## **Blast Management Strategy**

CHBPW-FGJV-NWW-EN-STG-000001- Revision D - Coffs  
Harbour Bypass

<b>Document Title</b>	Construction Blast Management Strategy
<b>Project Name</b>	Coffs Harbour Bypass
<b>Client</b>	Transport for New South Wales
<b>Application No.</b>	SSI-7666
<b>Document Reference No.</b>	CHBPW-FGJV-NWW-EN-STG-000001
<b>Principal Contractor</b>	Ferrovial Gamuda Joint Venture

Revision	Date	Description	Approval
A	March 2023	Draft for suitably qualified and experienced person review	
B	March 2023	Update in response to qualified and experienced person review	
C	April 2023	Update in response to TfNSW, ER, AA and EPA review	03/05/3023
D	June 2023	Update in response to DPE review

# Controlled Blast Locations

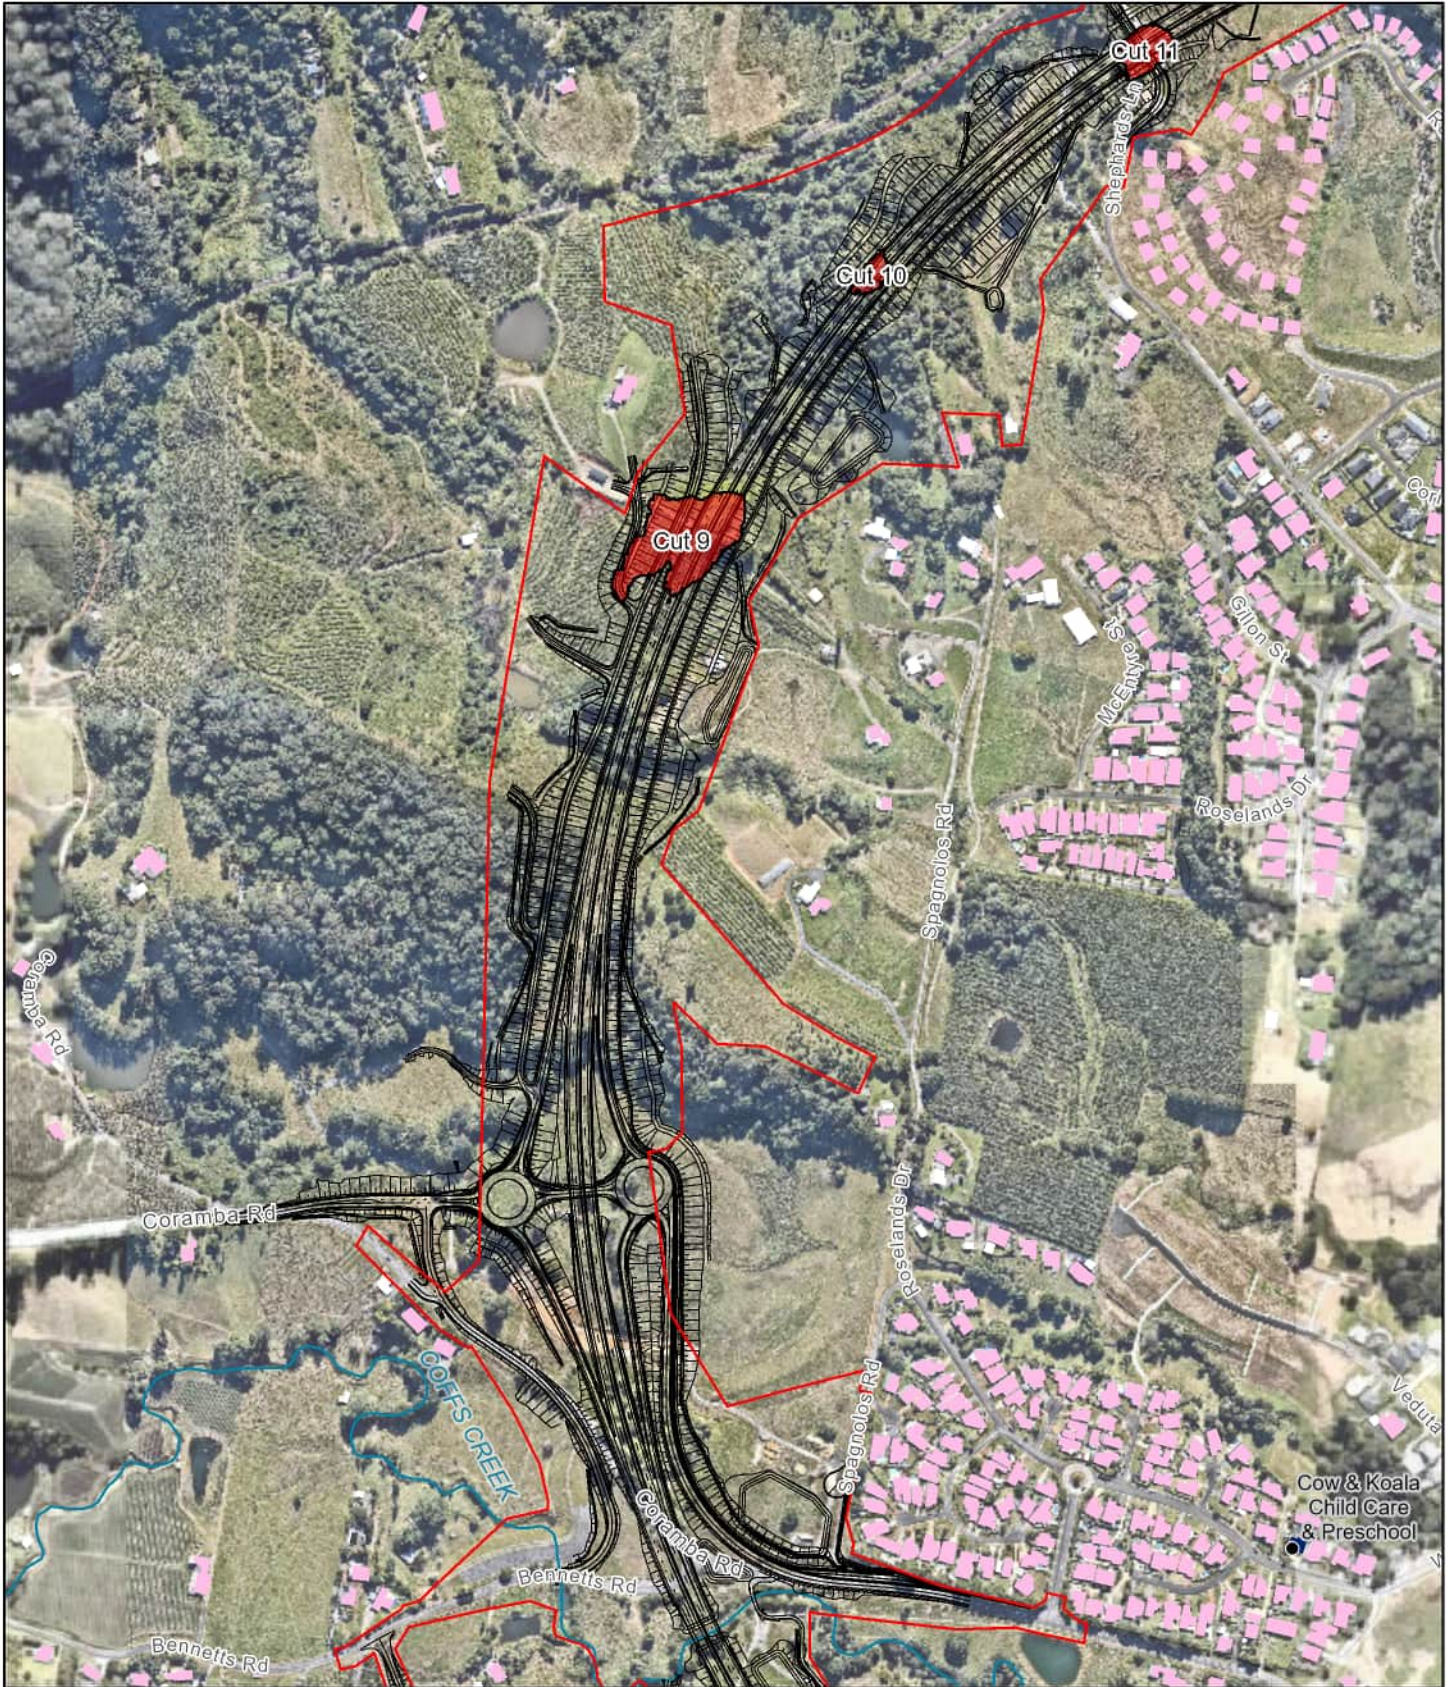
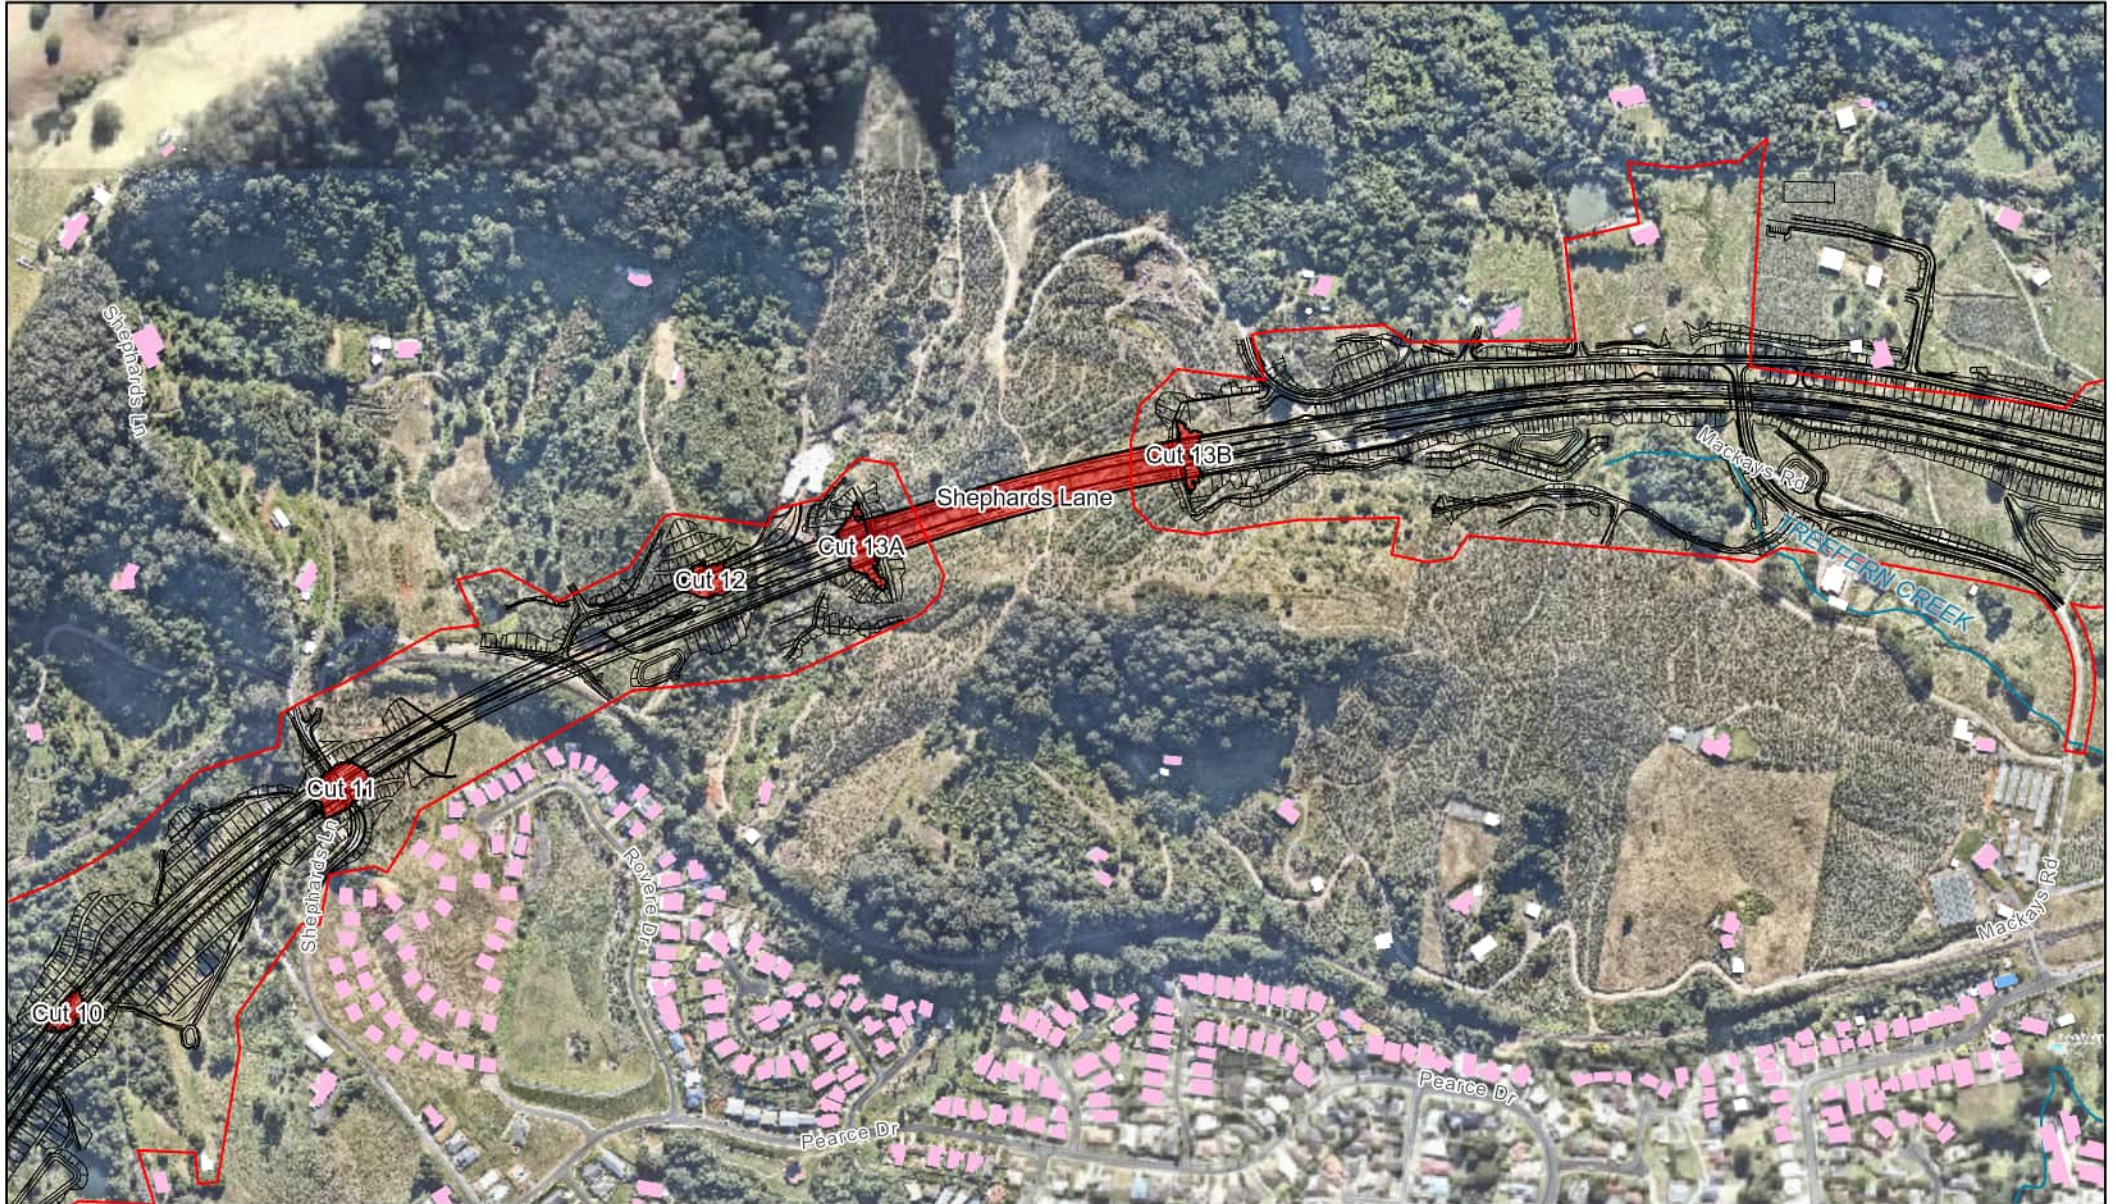
2	29/03/2023	B	ER	GeoLINK	Appendix 3		While the maps in Appendix 3 are clear with high resolution aerial photos, there is no way to cross reference with the locations listed in Table 3. Please provide 'cut/tunnel' labels and/or chainages on the maps.		Maps updated with labels detailing cut numbers and tunnel names.	Y				
3	29/03/2023	B	ER	GeoLINK	Sections 3.1 & 3.3	MCOA E59(b)	The document states that blasting may occur up to 4 times per day in tunnels and 2 times per day in cuttings, and that blasting will start about Sept 2023 and continue for approx. 24 months. More detail should be provided. E.g. is this regularity the same at all blasting locations? Will the stated blasting rates be continuous or intermittent throughout the 24 months? What is the duration of blasting at different locations? This is related to comment #5 below regarding the lack of a blasting program.		Indicative number of blasts and program included in Section 3.2 (Table 4).	Y
